DISCUSSION of:

Ground Improvement Using Preloading with Prefabricated Vertical Drains

Bengt H. Fellenius, Dr. Tech., P.Eng., Canada; email: bengt@fellenius.net

Figure 1. Settlement measured at the benchmarks shifted 10 days.

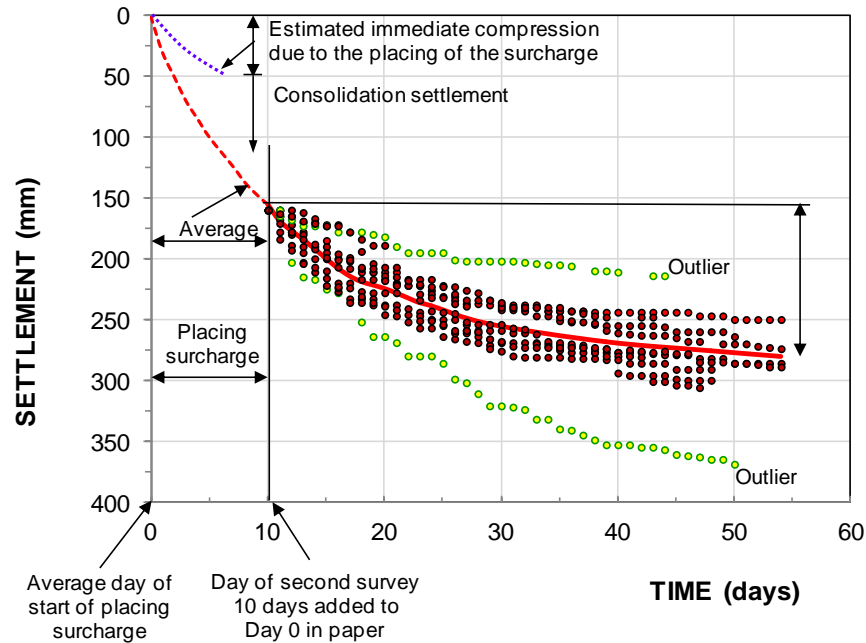
The authors report, that the first survey of the benchmarks was taken before the 3.0-m surcharge was placed across the test area. The first day of settlement measurements for the twelve benchmarks was the date of the second benchmark survey, which was carried out only when all of the surcharge had been placed to the full height over the test area. The time between the first and second surveys—and the placing of the surcharge—ranged from a few days to twenty days. Because the times between the placing of the surcharge and the second survey differed for the benchmarks, the amount of settlement that had occurred at the time of the second survey also differed between the benchmarks. This explains some of the significant scatter displayed in the authors' Figure 13. I have re-plotted the measured settlements in Figure 1 to a common starting point at the average start settlement of 160mm and added 10 days to the authors' measurement days to indicate the average duration of placing the surcharge, which took place before the second survey. During this time, immediate compression and some consolidation will have occurred. As indicated, I estimate the immediate compression to be about 50 mm. I have also added an average curve and extrapolated it back to the origin (the average excludes the two outlier records). All benchmarks appear to show that most of the consolidation had developed at the time the last survey was made.

Figure 2. Settlement measured at the benchmarks normalized to the average end values.

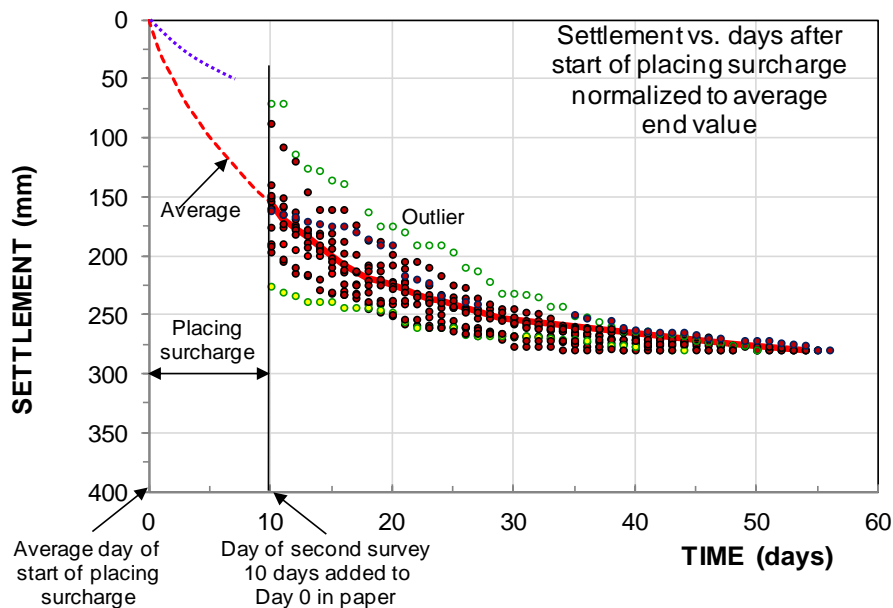
Figure 2 shows the measured final settlements are normalized to the average final settlement (280 mm). There is still much scatter between the curves, but now the approximate start date for each curve can be obtained by sliding the curves left or right until the best agreement to the average curve is obtained as shown in Figure 3. The removal of much of the scatter—the agreement between the time-settlement curves—is of course to some extent fictitious as the benchmark measurements cannot be expected to be all that similar; a natural variation must have taken place, not least with regard to the thickness of the soft clay layer. However, I believe that the figure suggests a reasonably realistic day for the start of placing the surcharge.

Figure 3. Settlement measured at the benchmarks adjusted to obtain the approximate start day.

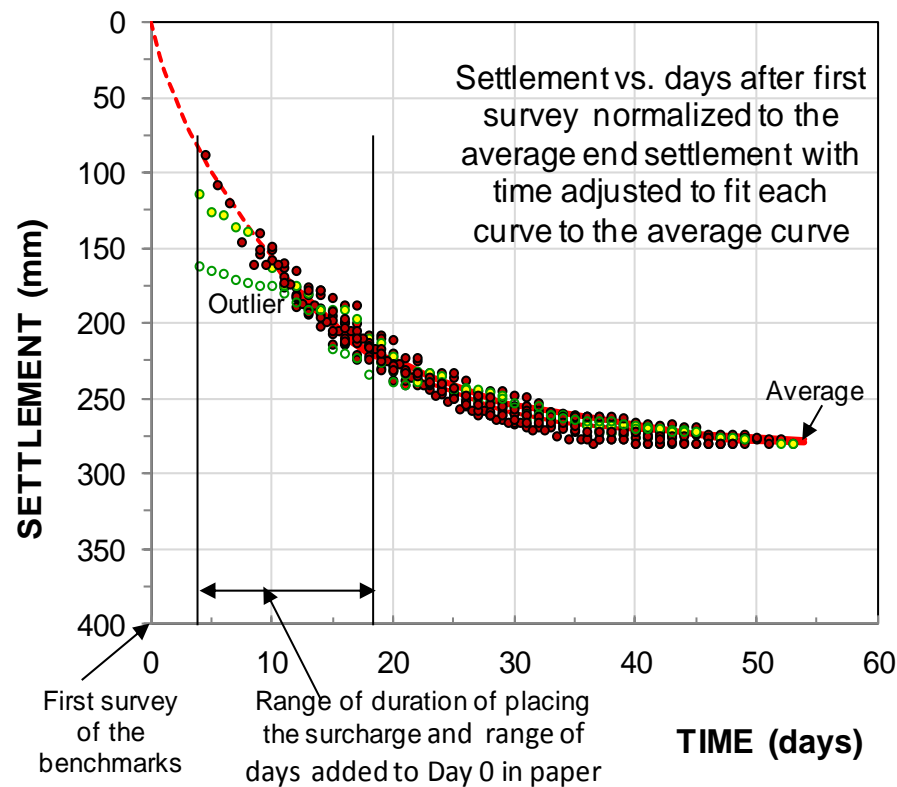
The average curve shown in Figure 3 can now serve as reference to a back-calculation of the time-settlement development for the wick-drain project to determine compressibility and coefficient of consolidation of the soil layers. The back-calculation consists of applying the theory of pore pressure dissipation in fine-grained soils (consolidation) due to radial flow (Barron 1948, Kjellman 1948, and Hansbo 1960; 1979) is based on radial flow toward a circular drain in the center of a cylinder of homogeneous soil with an impervious outer boundary surface). The theory is summarized in the Kjellman-Barron formula, Equation 1. The Kjellman-Barron formula is based on the assumption of horizontal (radial) flow only and a homogeneous soil.

Figure 4. Average measured and calculated settlements.

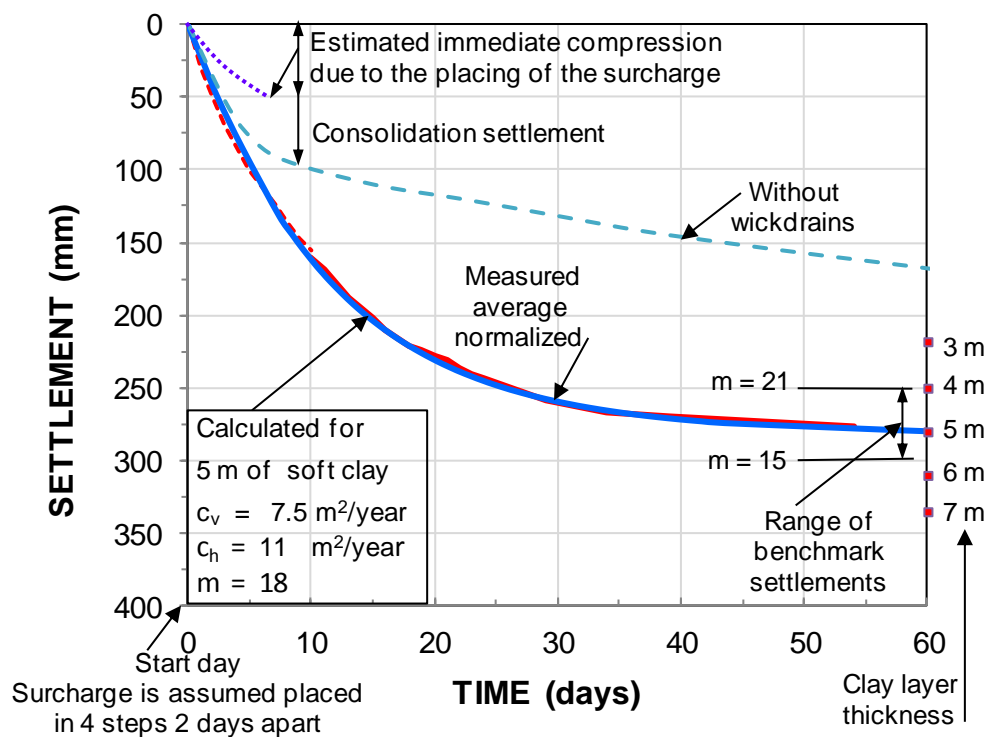
The results of the back calculation are shown in Figure 4 together with the average curve of the measurements. In order to show the sensitivity of the clay layer thickness and modulus number, the figure also shows the final settlement for soil layer thickness ranging from 3 through 7m and the final settlement resulting from modulus numbers of 15 and 21. The figure also shows the settlement during the first 60 days that would have occurred had there been no wick drains (for this input, I used the authors' $7.5 \text{ m}^2/\text{year}$ c_v -coefficient).

Considering that my data reduction is quite different to that of the authors, my back-calculated c_h -coefficient ($11 \text{ m}^2/\text{year}$) agrees well with the authors' laboratory-established value ($14 \text{ m}^2/\text{year}$). The difference could be taken to represent the effect of a smear zone. However, considering all the uncertainties involved, I believe the agreement to be entirely fortuitous.
